8. Well Name and No.
AVALON FEDERAL 1

9. API Well No.
30-015-35950-00-S1

COG Operating LLC respectfully requests to recomplete the Avalon Federal #1.

Avalon Federal #1 Recompletion Plan 30-015-35950

COG Operating, LLC
Proposed WBD

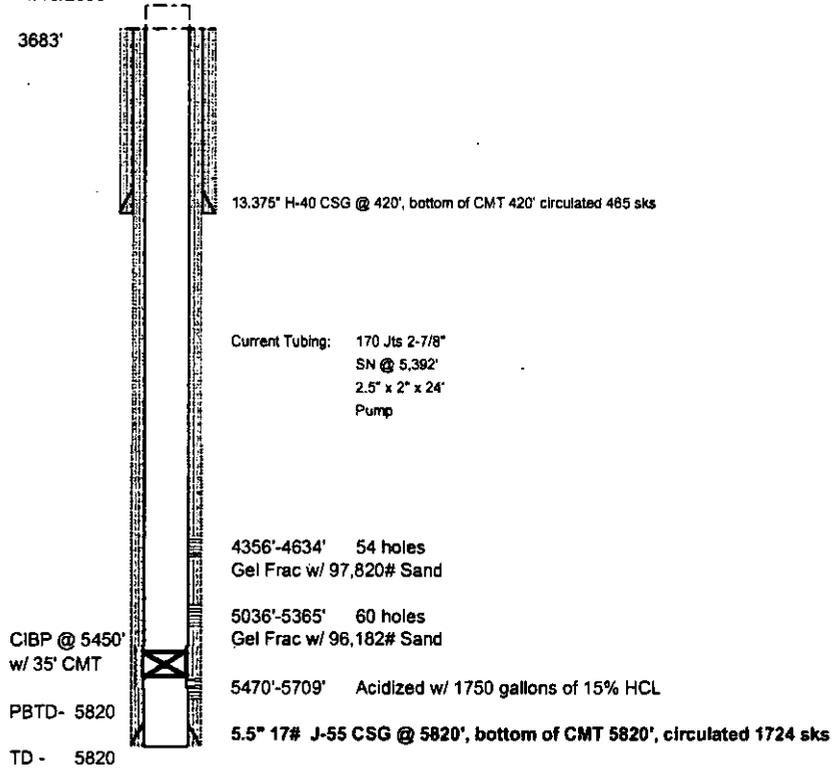
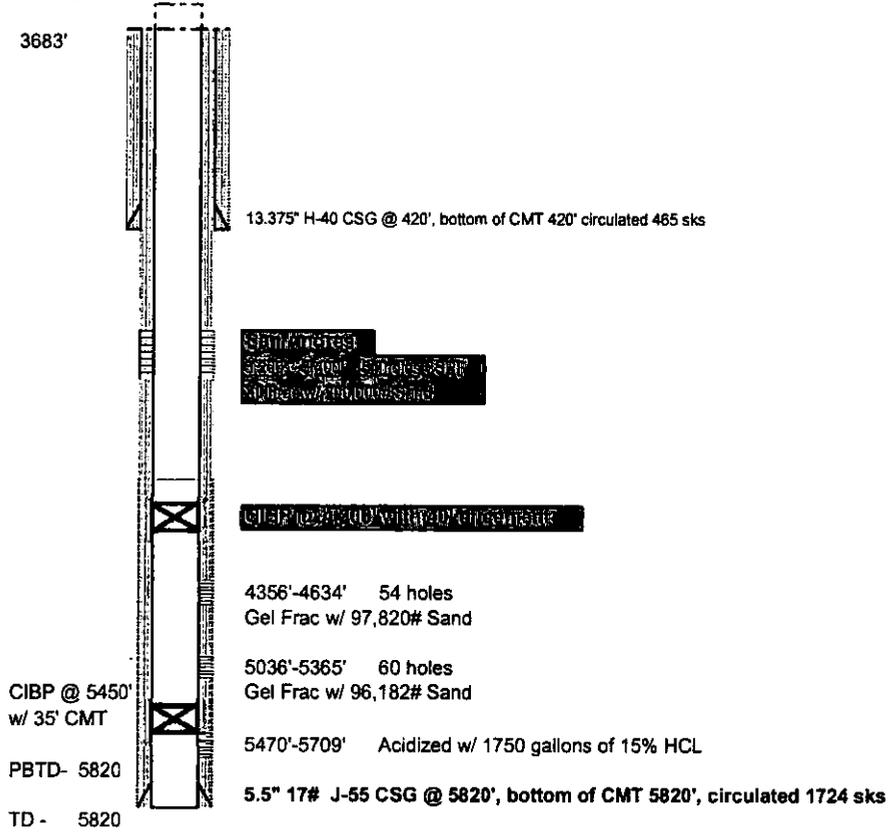
**** BLM REVISED ** BLM REVISED ** BLM REVISED ** BLM REVISED ** BLM REVISED ****

We are going to set a CIBP at 4,306' (50' above the paddock perms) w/ 40' of CMT on top of the plug to have our PBTD @ 4,266'. We plan to have our top perms from 3,200' – 3,400'. Ideally, we like to have the additional space of rat hole below our bottom perms to give our bottom hole assembly room and prevent tubing from getting stuck with sand. In addition to having desired rat hole space, this gives COG the option to re-enter the paddock formation at a later time.

- MIRU WSU, NU BOP
- Unset pump and POOH with rod and tbg
- PU scraper and scrape down to 4,350'
- RU Wireline
- Make gauge ring/ junk basket run
- **SECURITAGE**
- Wireline truck dump 40' Class C cement of top of CIBP
- **the cement plug to a depth of 400'**
- Pull up 4' to circulate hole clean with fresh water, and displace w/ 2% KCL and 1% packer corrosion inhibitor.
- Test Casing to 4,300 psi and report back to engineering if the pressure holds.
- RIH w/ perforating guns and perforate San Andres Zone from 3,200'-3,400', w/ 3 spf, 120° phasing, 54 holes
- Dump bail acid in the perf interval
- NU 5K frac valve
- Secure wellbore
- RDMO WSU
